Addendum No. 2
February 2, 2026

Project: Sioux Falls Washington and Roosevelt High School Auditorium Renovations
Sioux Falls, South Dakota
Project #3021

Architect: Architecture Incorporated

FINISH PLAN - LEVEL 1
 SCALE: 1/8" = 1'-0"

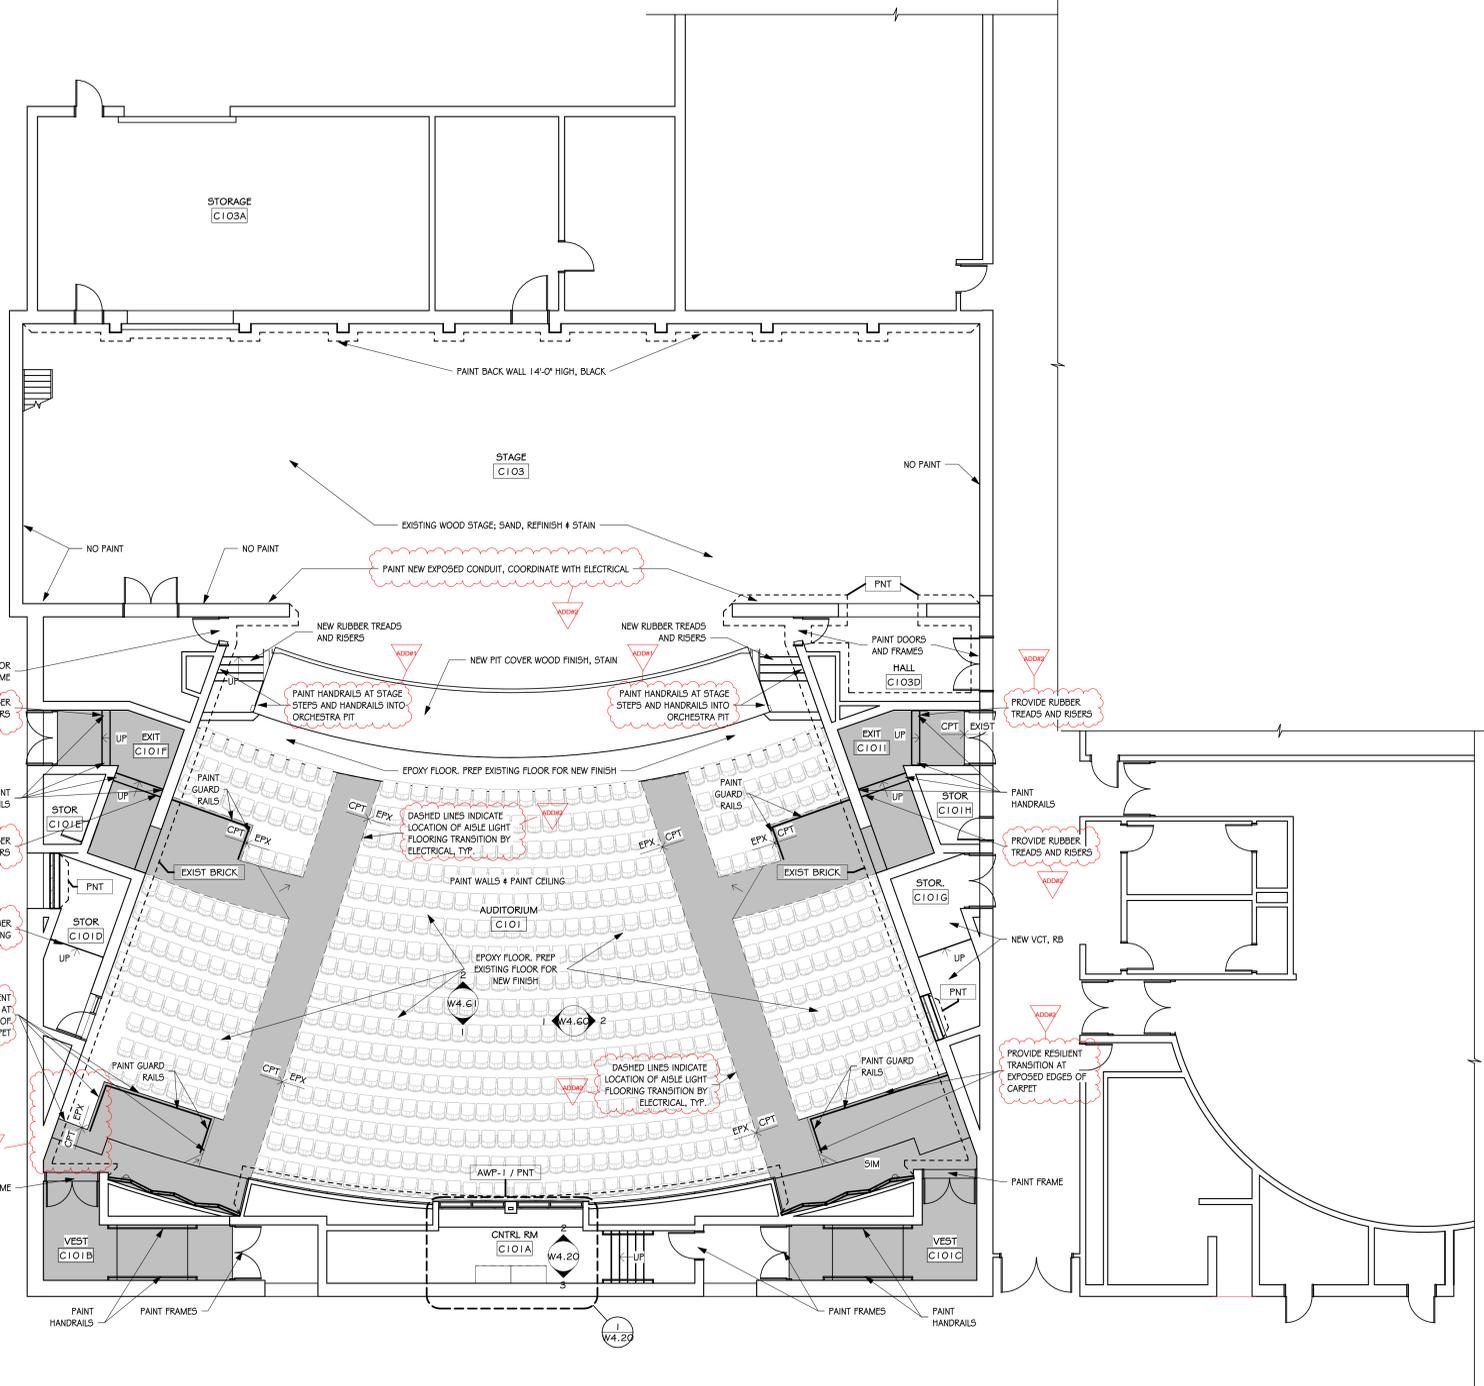
- 6) SHEET W4.20 – FINISH PLAN – LEVEL 1
- a) Paint new electrical conduits on south wall of stage as shown on drawing. Coordinate locations with electrical.

- b) Revise location of carpet transition at southwest corner of Auditorium.
 - c) CLARIFICATION: Refer to revised drawing sheet W4.20 for clarification of flooring transition types and locations. Coordinate with electrical drawings.

- d) CLARIFICATION: Refer to revised drawing sheet W4.20 for clarification of rubber nosings and tread and riser locations.
 - e) Reference revised drawing Sheet W4.20, revision dated 2-2-26, attached to the end of this addendum.

FINISH PLAN - BALCONY
SCALE: 1/8" = 1'-0"

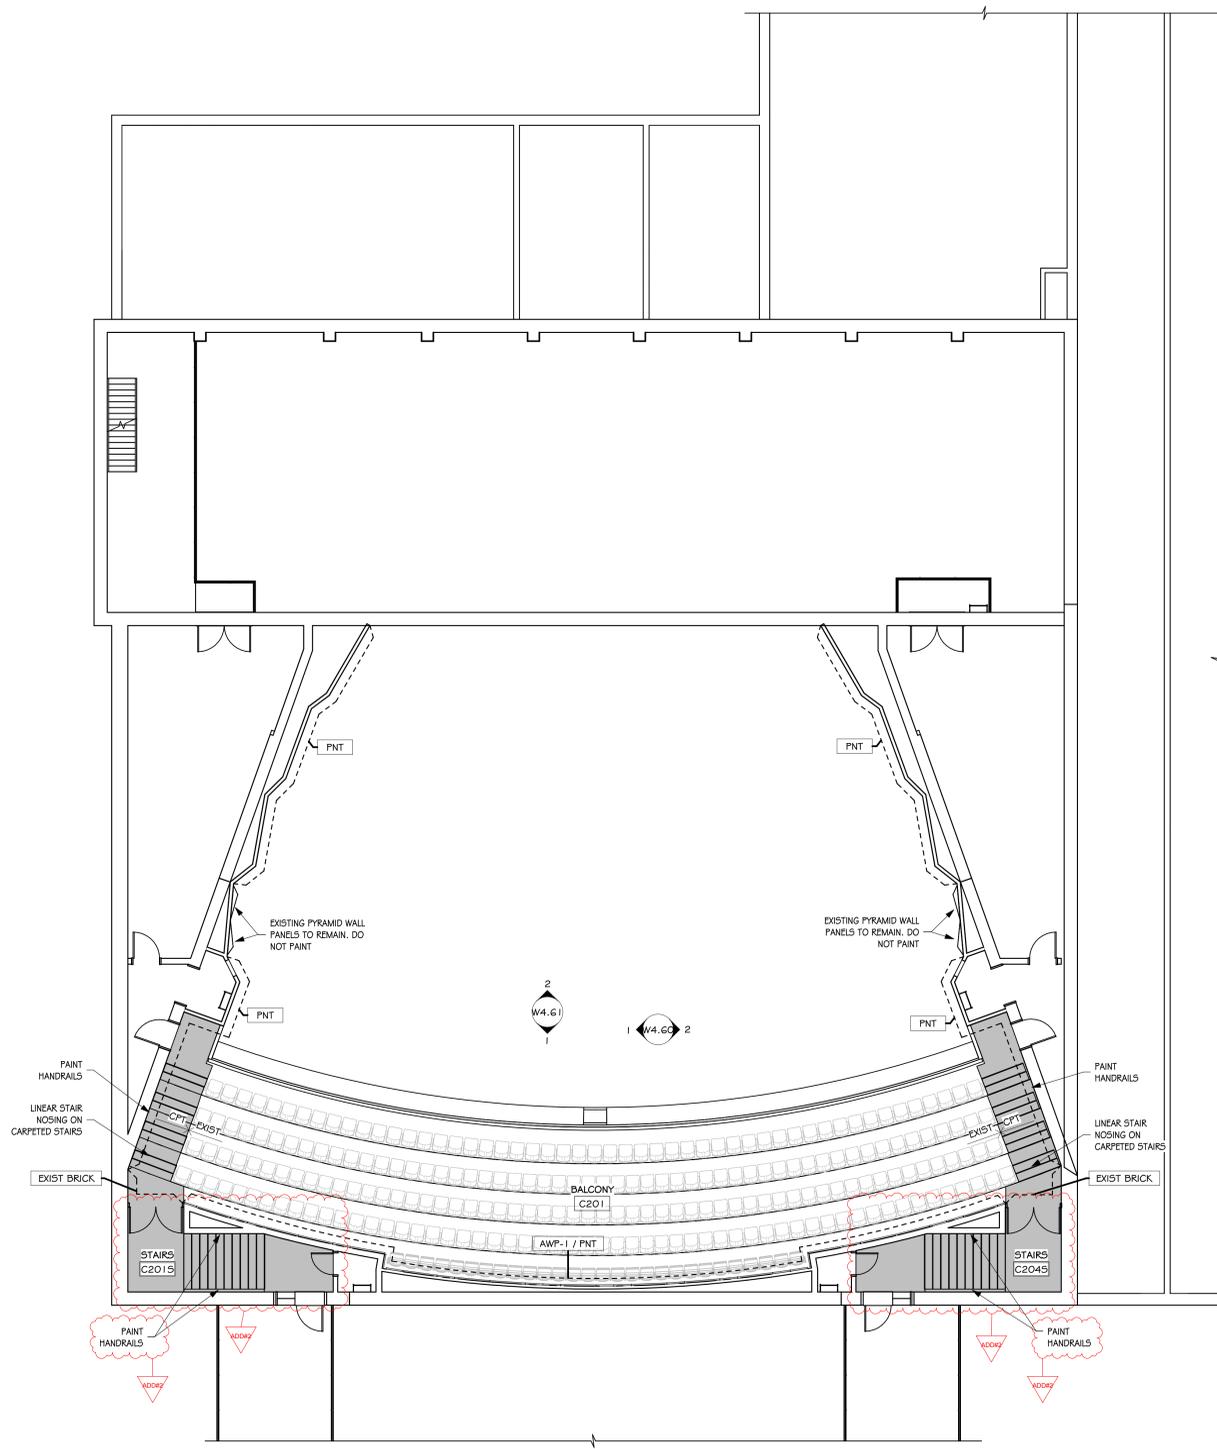
- 8) SHEET W4.21 – FINISH PLAN – BALCONY
- a) Omit reference to painting metal guardrail at balcony. Aluminum rail to remain no finish.
 - b) Reference revised drawing Sheet W4.20, revision dated 2-2-26, attached to the end of this addendum for room finishes added for C210S Stairs and C204S Stairs and painting handrails at stairs.

2 PROJECTOR OPENING - SECTION DETAIL
SCALE: 1 1/2" = 1'-0"

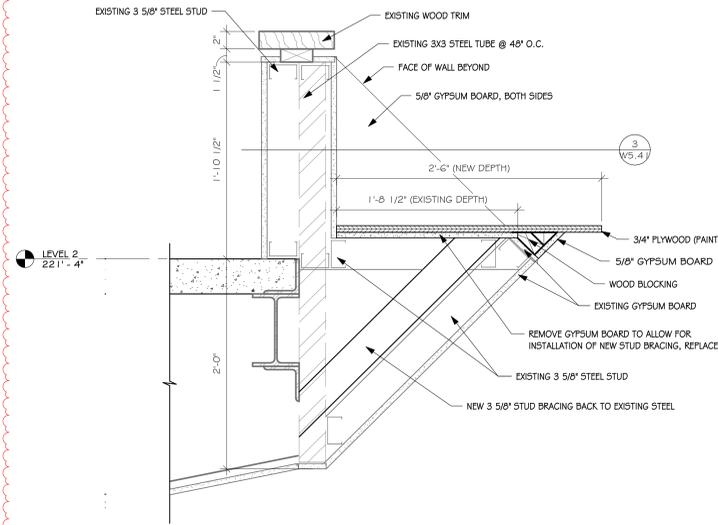
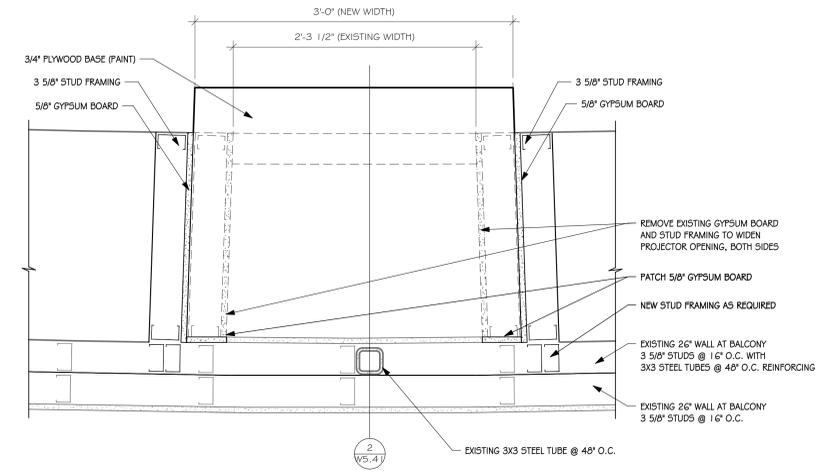
- a) Omit reference to painting metal guardrail at balcony. Aluminum rail to remain no finish.
- 12) SHEET W5.41 – DETAILS
- a) See details 2/5.41 and 3/5.41 for revisions to gypsum board balcony framing for installation of video projector. Existing space width will be wider. Section detail 2/W5.41 in reference to section 1/W5.20. Plan detail 3/W5.41 in reference to plan view of projector opening on W4.11.

- b) Reference revised drawing Sheet W5.41, revision dated 2-2-26, attached to the end of this addendum.
- 13) SHEET R5.41 – DETAILS
- a) See details 2/5.41 and 3/5.41 for revisions to gypsum board balcony framing for installation of video projector. Existing space width will be wider. Section detail 2/R5.41 in reference to section 1/R5.20. Plan detail 3/R5.41 in reference to plan view of projector opening on R4.11.

REFLECTED CEILING PLAN - FIRST FLOOR
SCALE: 1/8" = 1'-0"

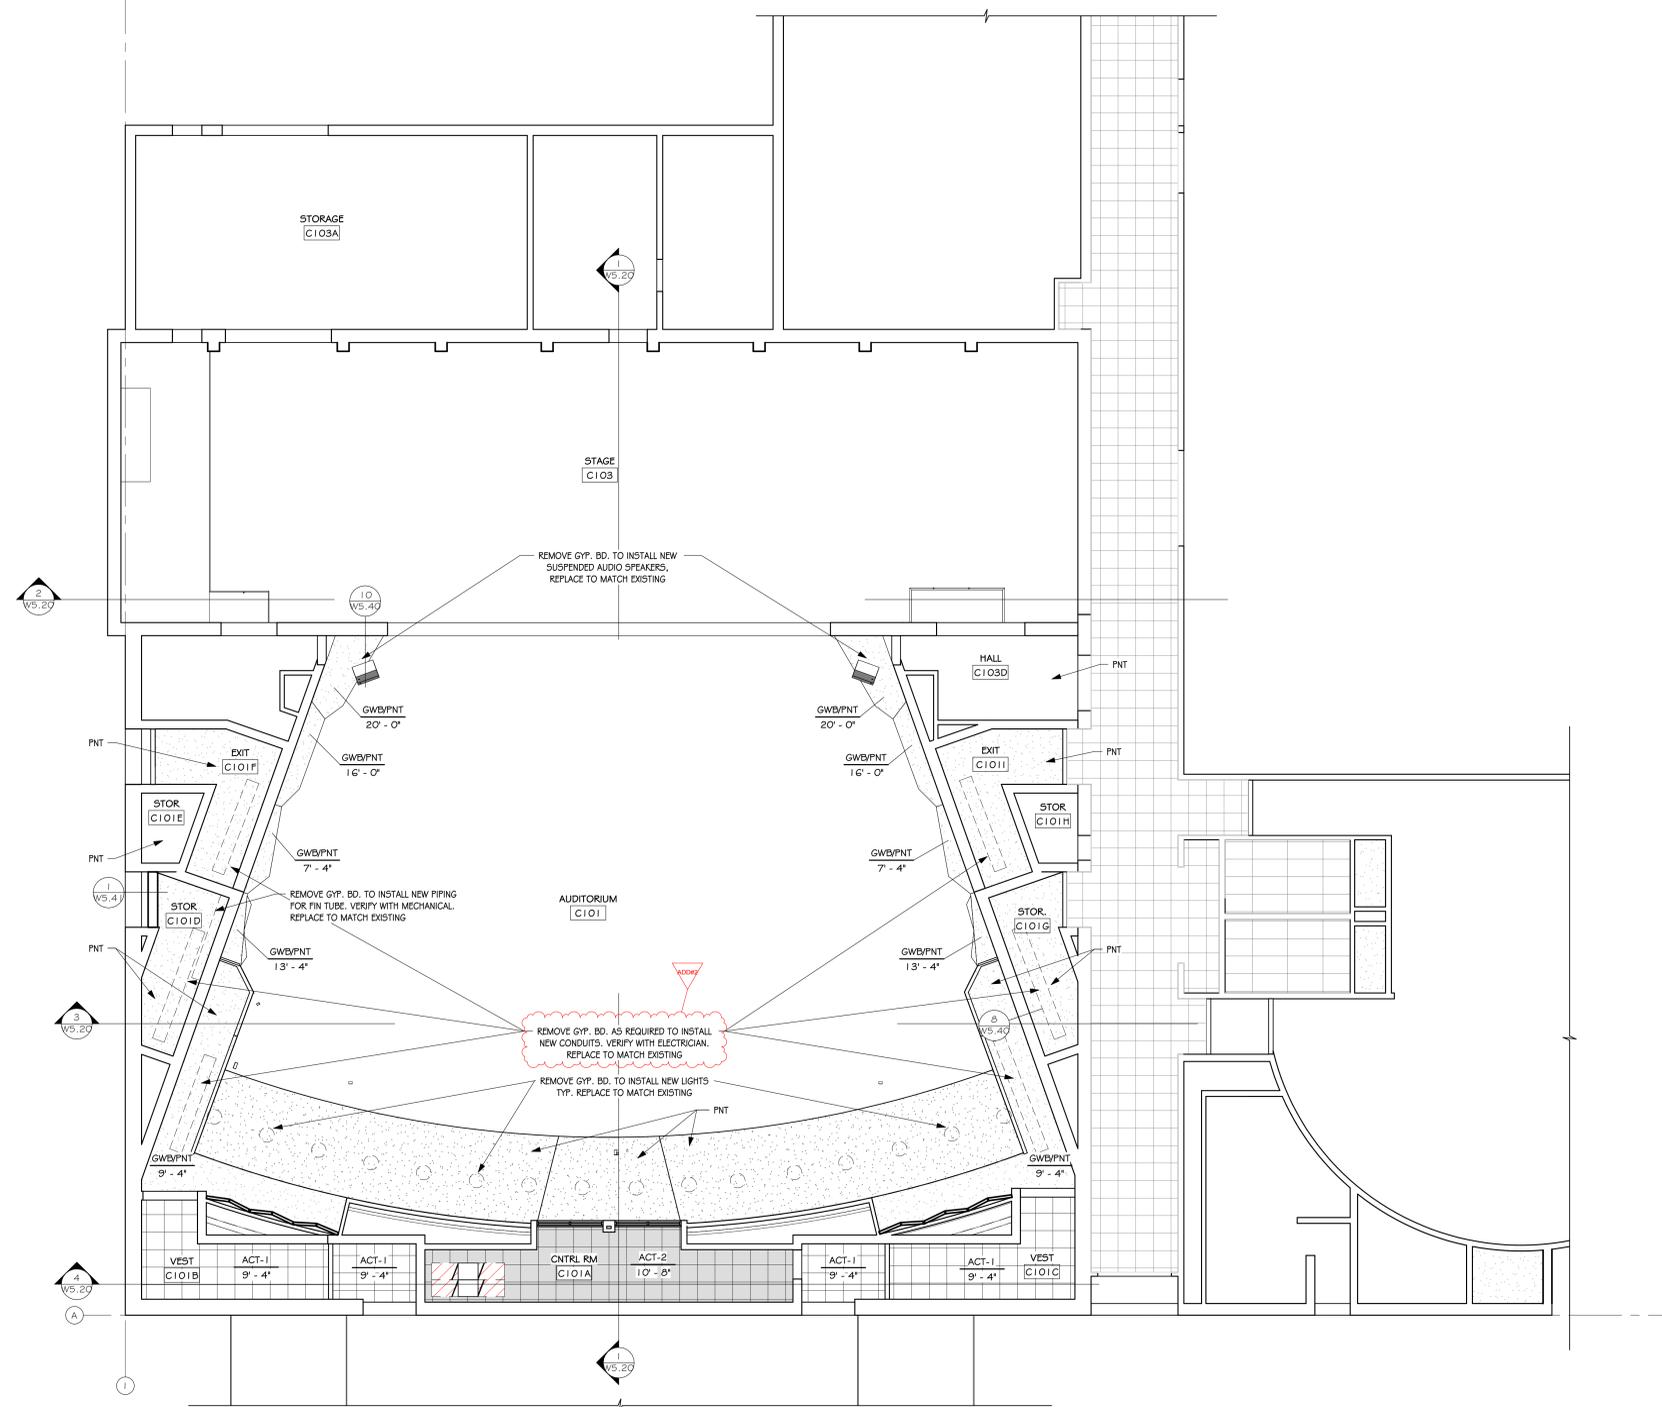
- 14) SHEET W6.10 – REFLECTED CEILING FIRST FLOOR
- a) Reference revised drawing Sheet W6.10, revision dated 2-2-26, attached to the end of this addendum for additional gypsum board ceilings to be removed and replaced to allow installation of new electrical conduit. Coordinate locations with electrical.

R4.10

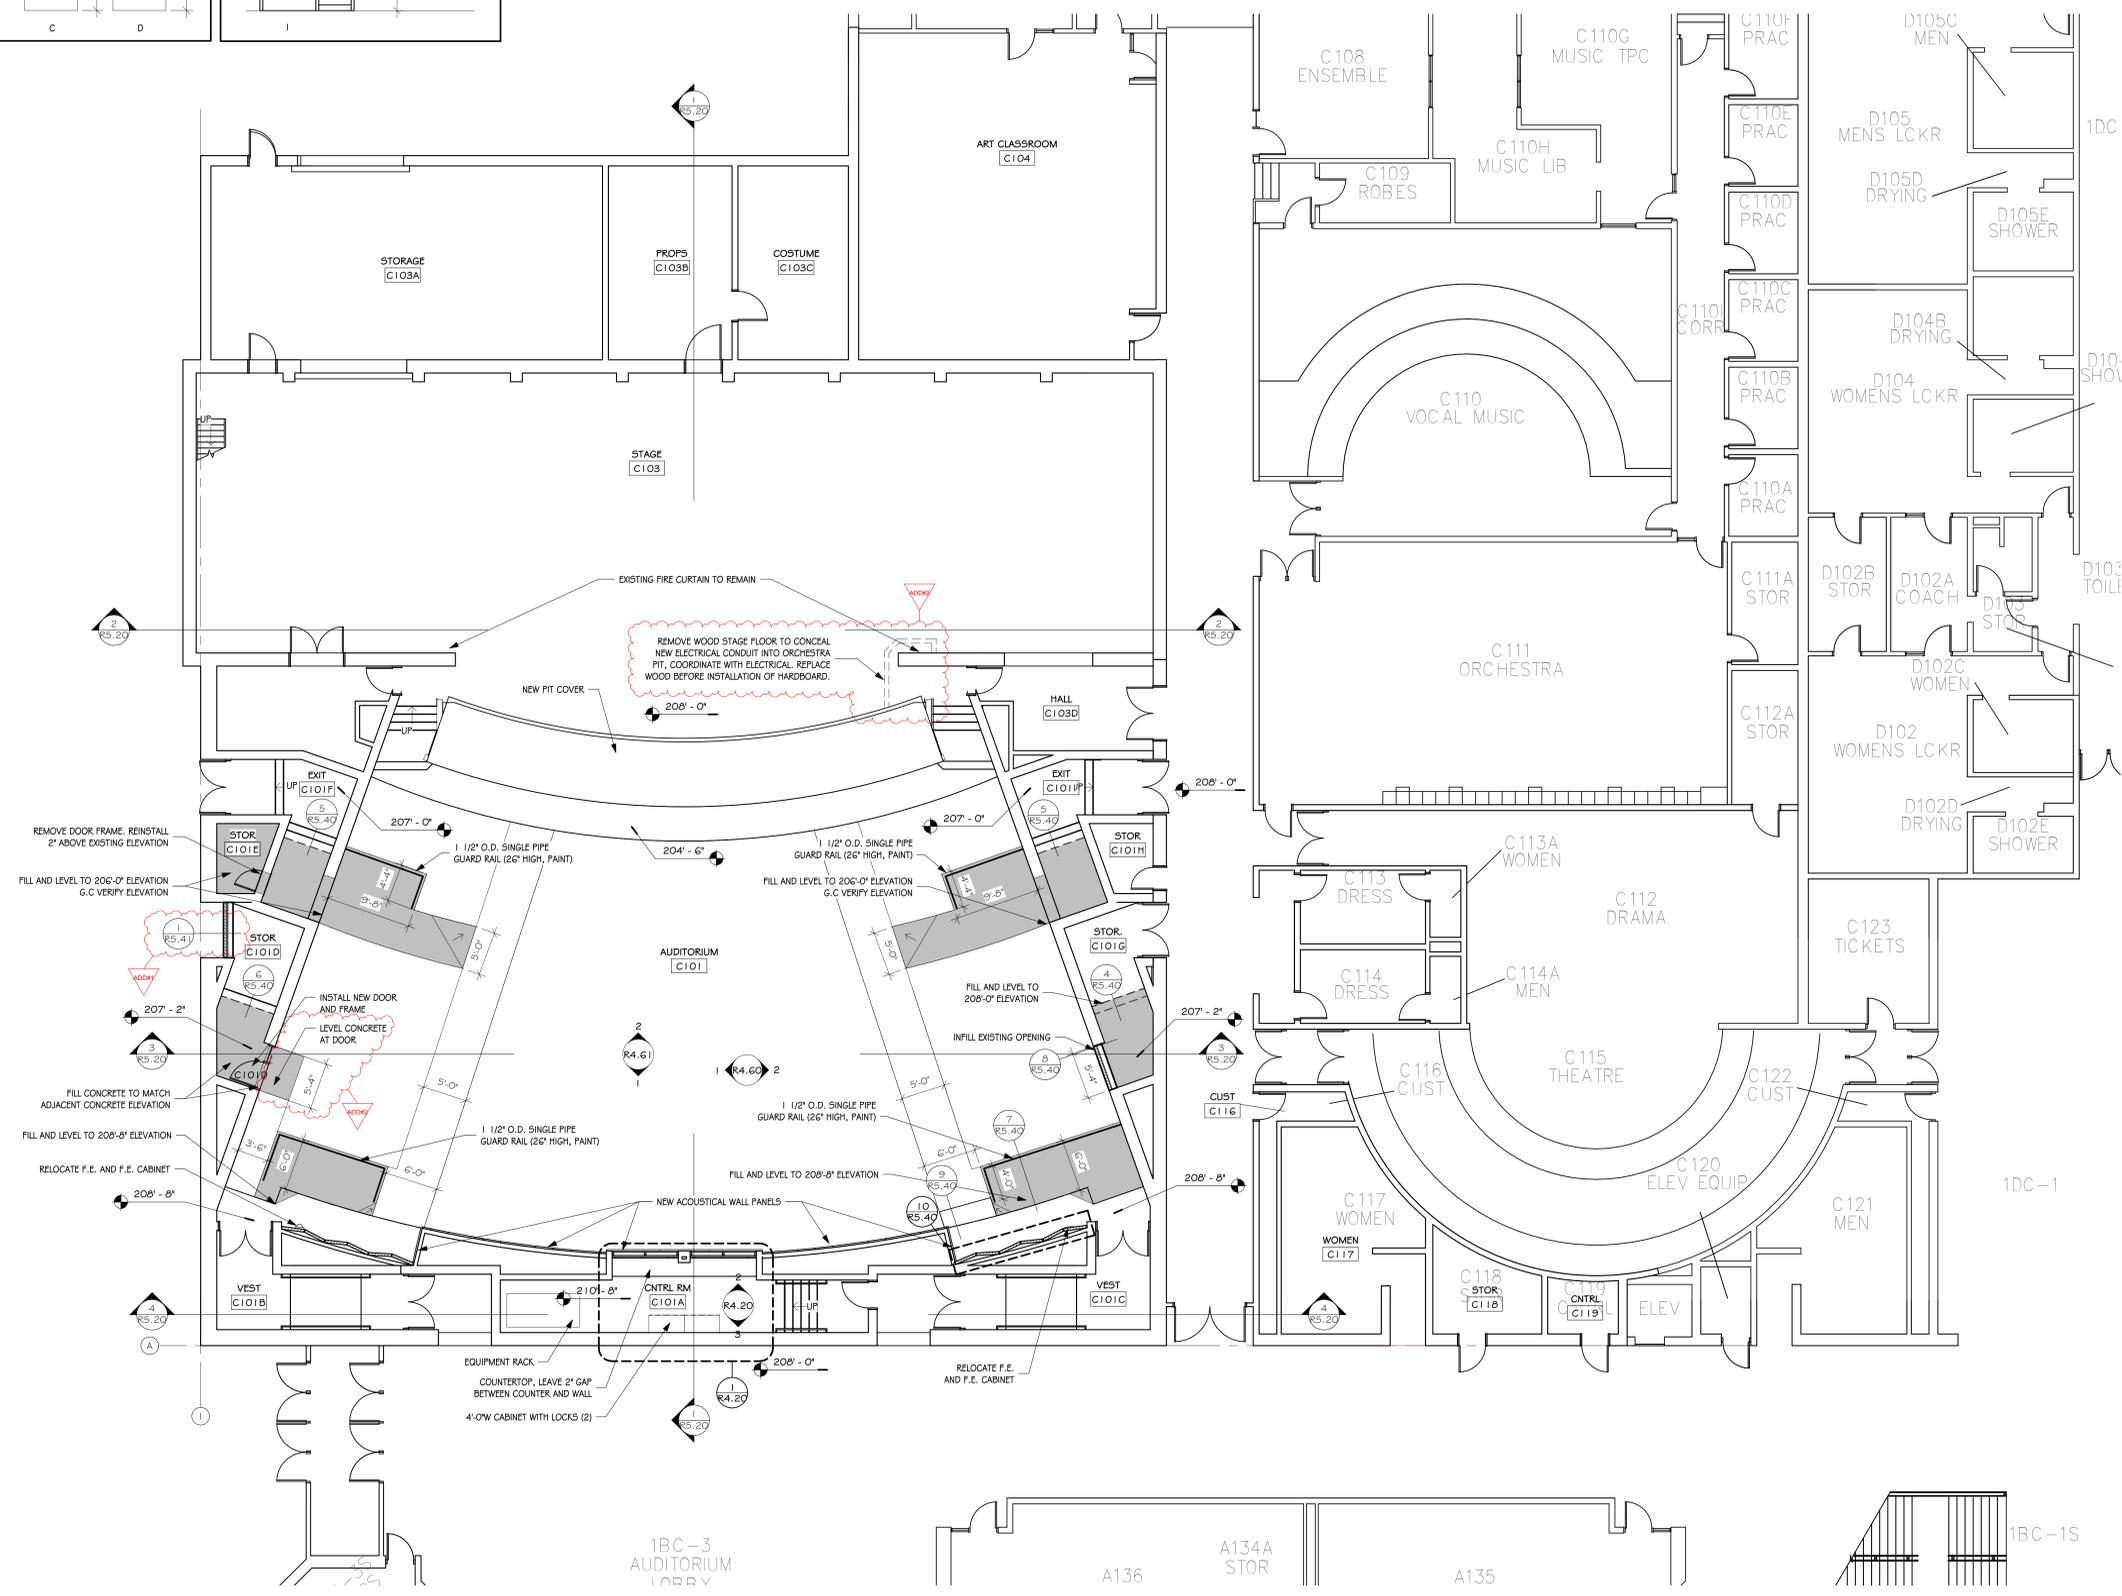
- 5) SHEET R4.10 – FLOOR PLAN – LEVEL 1
 - a) See note on stage floor to remove and replace existing wood stage floor at location shown for new conduit into orchestra pit. Coordinate location with electrical.

- b) See note to level concrete floor at door C101D.
 - c) Reference revised drawing Sheet R4.10, revision dated 2-2-26, attached to the end of this addendum.
